CITY OF PORTLAND

BUILDING PERMIT

Located At 191 PINE ST

Job ID: 2012-07-4448-ALTCOMM

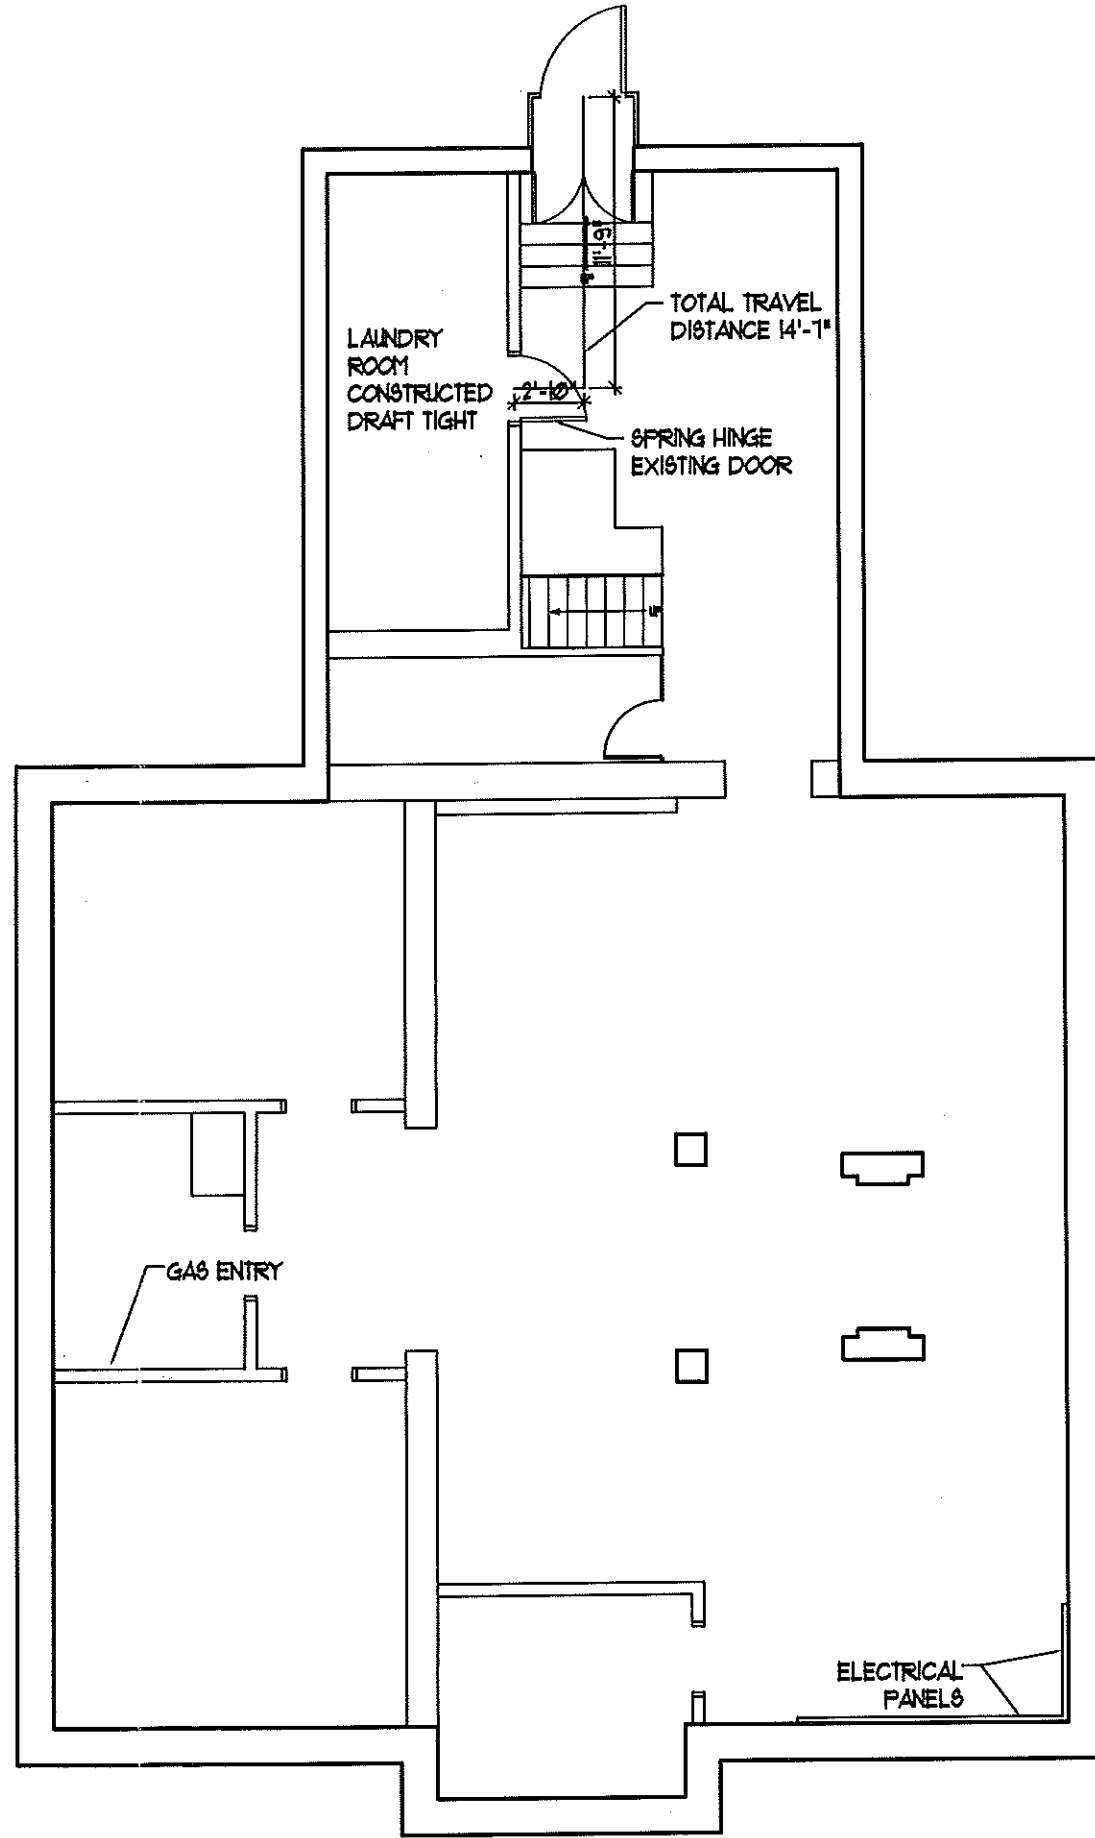
1. Justify energy code compliance with ResCheck or alternative and no insulation at the north wall See attached ResCheck
2. Plan 3.1 (4) calls out point load bearing for the new beams as 2-2x4, bearing is required for the full width of the beam The beams bear on a 2x4@16" stud wall with additional (2) 2x4 studs located at each beam. Full bearing is provided by a double 2x4 top plate.

3. Same plan, provide structural compliance of 2x6 T&G floor spanning 5'5” between beams Calculations show that bending stress is 34% of allowable, shear stress is 15% of allowable and the total load deflection is L/280.
